Form C-144
Revised June 6, 2013

PERMIT # 13253 Proposed Alternative Method Permit or Closure Plan Application

1.
Operator: Burlington Resources Oil & Gas Company, LP OGRID # 14538
Address: P.O. Box 4289, Farmington, New Mexico 87499
Facility or well name: LODEWICK 1S
API Number: 30-045-34271 OCD Permit Number: _____
U/L or Qtr/Qtr M Section 18 Township 27 N Range 9 W County: San Juan
Center of Proposed Design: Latitude 36.570107 °N Longitude - 107.836281 °W NAD: 1927 1983
Surface Owner: Federal State Private Tribal Trust or Indian Allotment

LODEWICK 1S (BELOW GRADE TANK)

**TIERRA CORROSION CONTROL, INC.
DRILLING LOG**

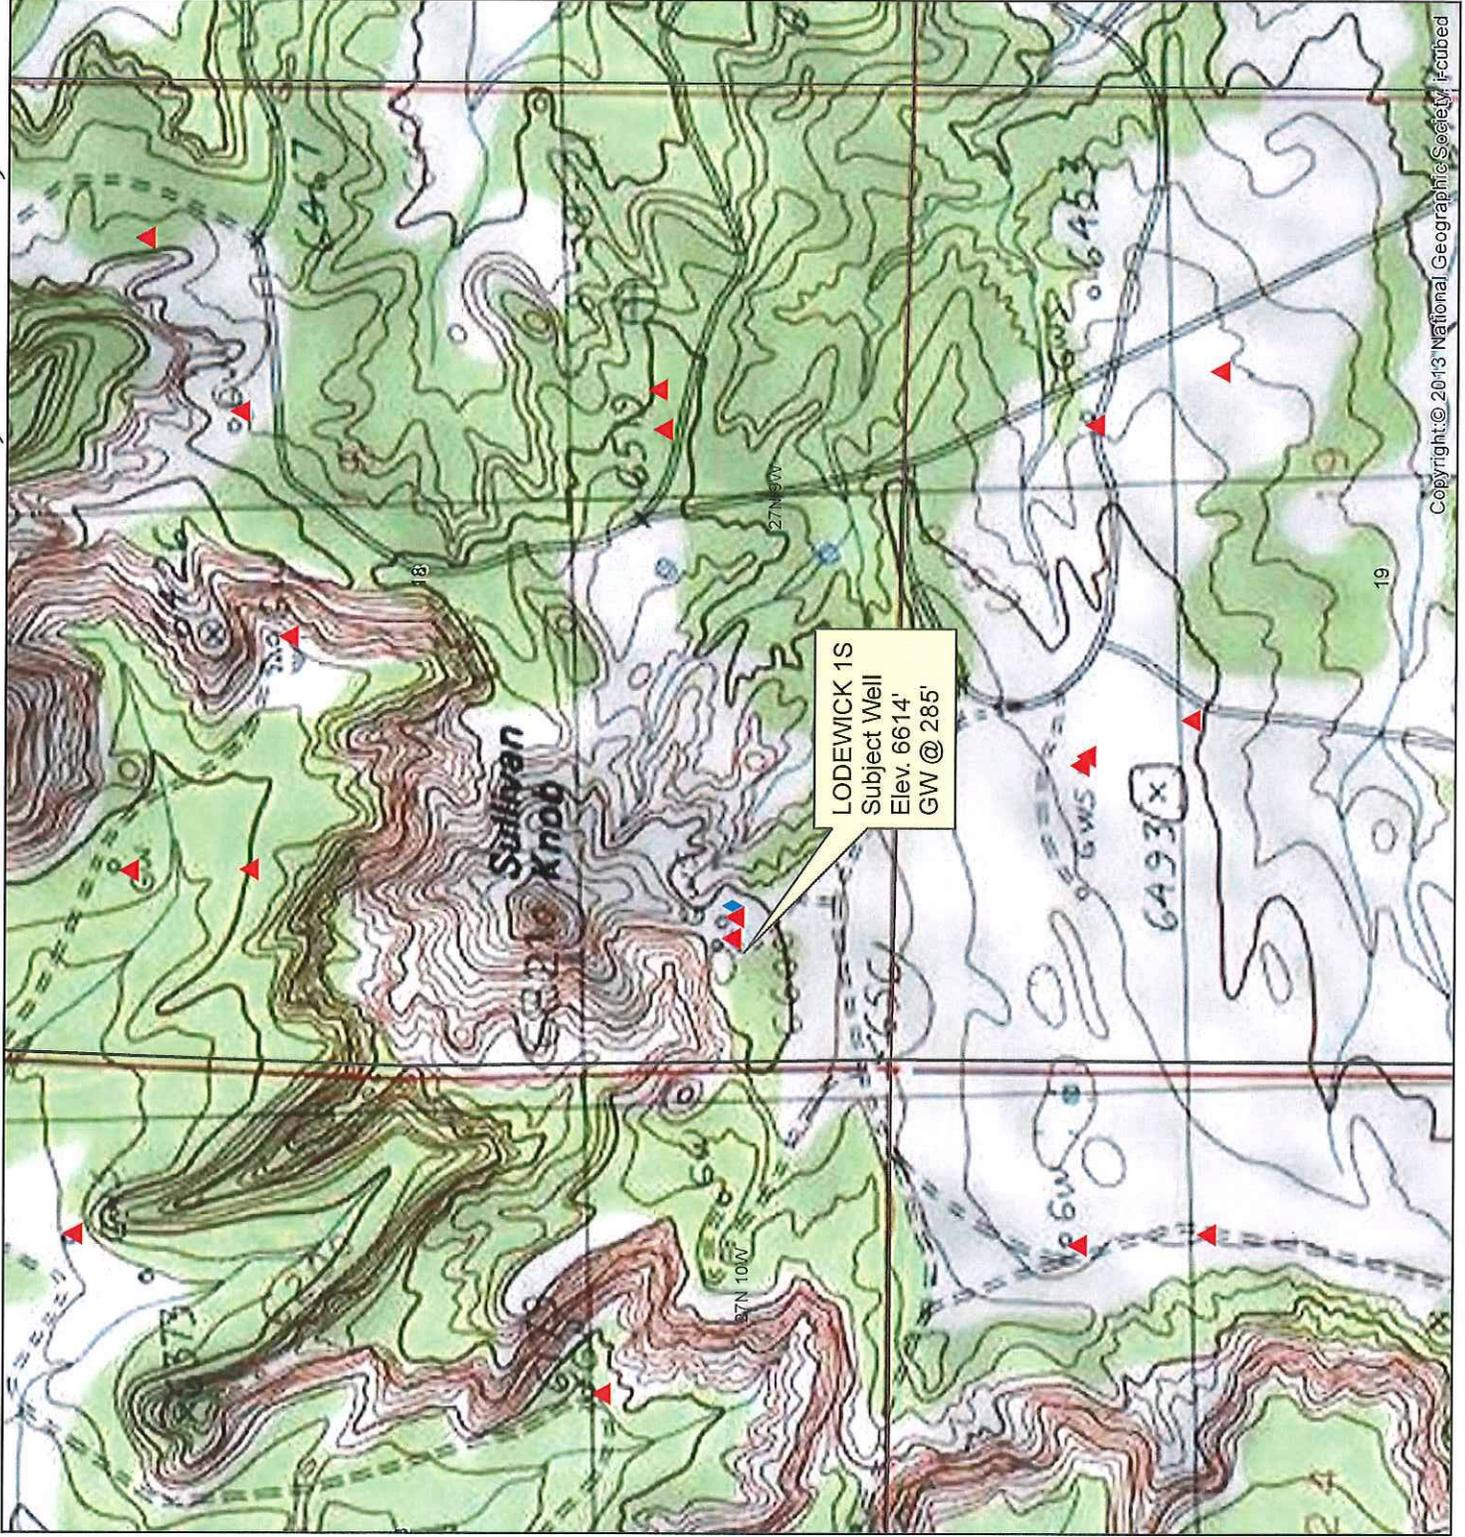
Insufficient Ground Water Data: Cathodic Well does not indicate Ground Water depth, Please review and resubmit.
